Subject: Planning consultation - WSCC/005/24

Having received further information regarding the supply of water fire firefighting for the proposed two temporary classroom blocks on existing playground with access from existing site compound, providing the details provided are implemented, suitable security device fitted to the gate when the school is closed i.e. a padlock and chain and a pathway added from the gateway to the hardstanding area, the condition will be met.

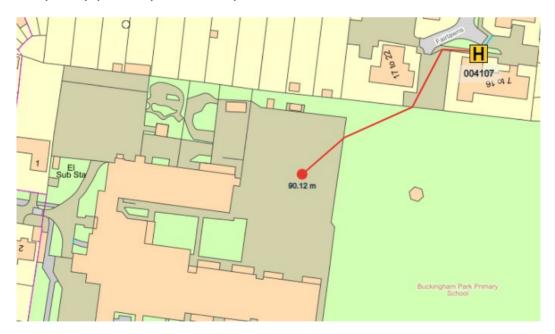
The plan attached of the Fairlawns access gate approach; I think this would be suitable providing there is guidance provided for any attending fire crews that the gate in the fence has been provided as access to the nearest fire hydrant. Also, there will need to be some form of pathway from the tarmac playing area where the fire appliance would be located to the gate. As recent weather conditions have shown in these wet conditions it is not easy to run out and pressurise firefighting hoses across wet and slippery grassed areas, so a temporary pathway will be required.

As you will see from our operational mapping below, this gate will give us access to a fire hydrant within 90m, which would be considered acceptable. If the gate needs to be secured when the school is closed or when in use, we need to ensure the attending fire crews can release the gate and gain access to Fairlawns. This can be either a padlock and chain or just a padlock, if we can get access to with a set of bulk croppers, we can cut the security device off. We do not have the ability to carry keys, unless a firefighters drop key is fitted, in which case we could gain access with the standard drop key.
